SUBJECT: TURKEY POINT NUCLEAR GENERATING UNIT NOS. 3 AND 4 - ISSUANCE
OF AMENDMENTS REGARDING OPERATING LICENSE CONDITIONS AND
TECHNICAL SPECIFICATIONS (TAC NOS. MF0602 AND MF0603)

The U.S. Nuclear Regulatory Commission (NRC or the Commission) has issued the enclosed Amendment No. 260 to Renewed Facility Operating License No. DPR-31 and Amendment No. 255 to Renewed Facility Operating License No. DPR-41 for the Turkey Point Nuclear Generating Unit Nos. 3 and 4, respectively. The amendments consist of changes to the Operating Licenses and the Technical Specifications (TSs) in response to your application dated September 14, 2012, as supplemented by letters dated January 29, February 14, May 30, and October 22, 2013, and March 11, 2014. Notably, the letter dated March 11, 2014, requested a reduction in scope of the license amendment request by removing the proposed change to TS Figure 3.1-2, "Boric Acid Tank Minimum Volume."

Amendment No. 260
Renewed License No. DPR-31

FIGURE 3.4-2 Turkey Point Units 3 & 4 Reactor Coolant System Heatup Limitations (Heatup Rates of 60 and 100°F/hr) Applicable for 48 EFPY (Without Margins for Instrumentation Errors)

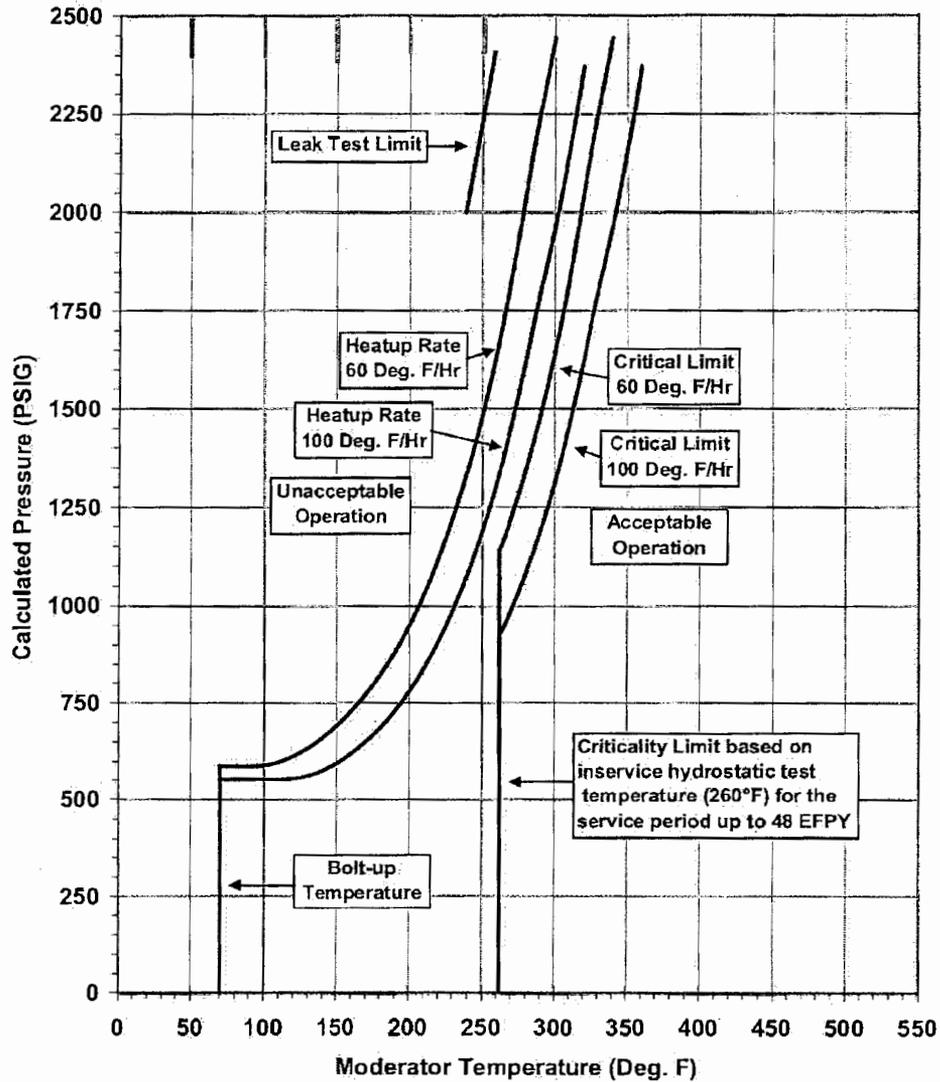
- On page viii, the index listing title, "FIGURE 3.4-2 TURKEY POINT UNITS 3&4 REACTOR COOLANT SYSTEM HEATUP LIMITATIONS APPLICABLE UP TO 32 EFPY [effective full power years]," would be changed to, "FIGURE 3.4-2 TURKEY POINT UNITS 3 AND 4 REACTOR COOLANT SYSTEM HEATUP LIMITATIONS (Heatup Rates of 60 and 100°F/hr) APPLICABLE for 48 EFPY (Without Margins for Instrument Errors)."
- On page viii, the index listing title, "FIGURE 3.4-3 TURKEY POINT UNITS 3&4 REACTOR COOLANT SYSTEM COOLDOWN LIMITATIONS (100°F/hr) APPLICABLE

FIGURE 3.4-3 Turkey Point Units 3 & 4 Reactor Coolant System Cooldown Limitations (Cooldown Rates of 0, 20, 40, 60 and 100°F/hr) Applicable for 48 EFY (Without Margins for Instrumentation Errors)

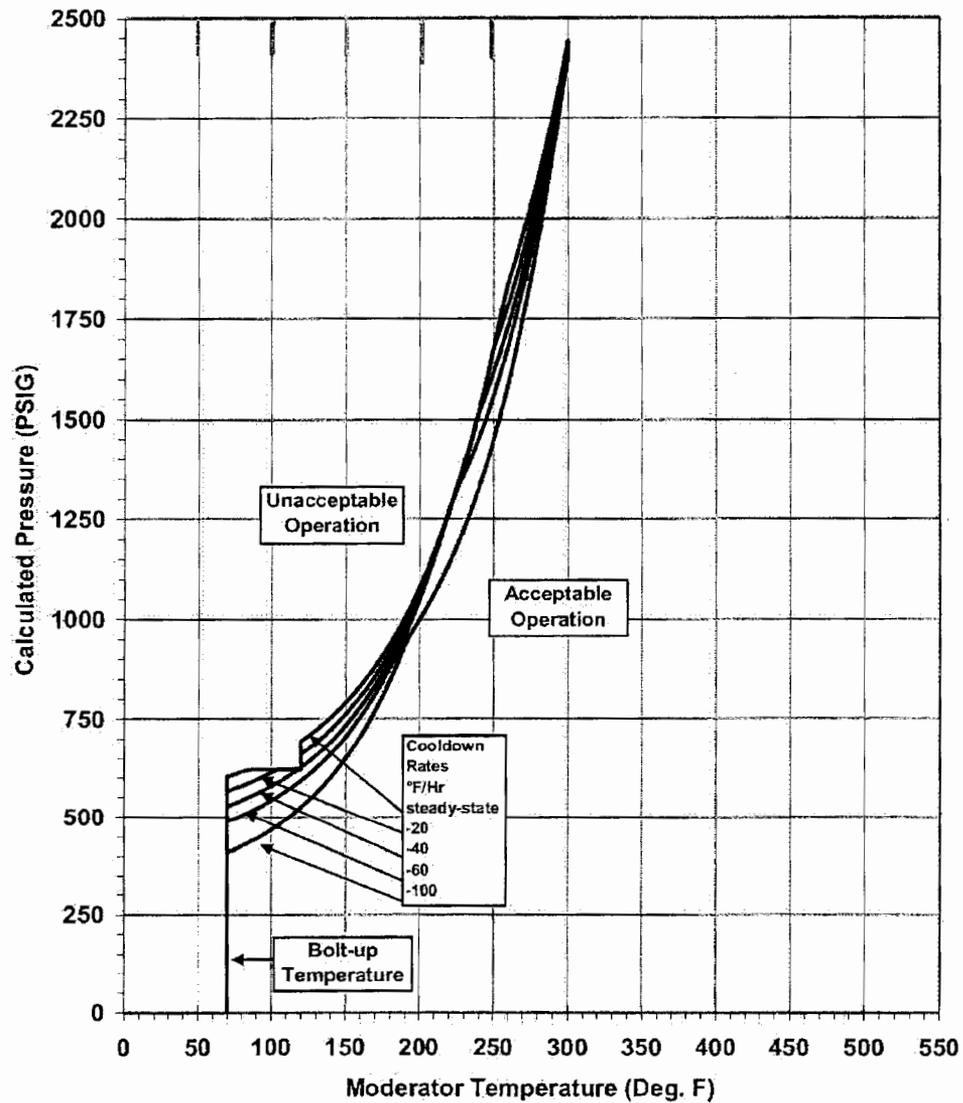
TO 32 EFY” would be changed to, “FIGURE 3.4-3 TURKEY POINT UNITS 3 AND 4 REACTOR COOLANT SYSTEM COOLDOWN LIMITATIONS (Cooldown Rates of 0, 20, 40, 60, and 100°F/hr) APPLICABLE for 48 EFY (Without Margins for Instrumentation Errors).”
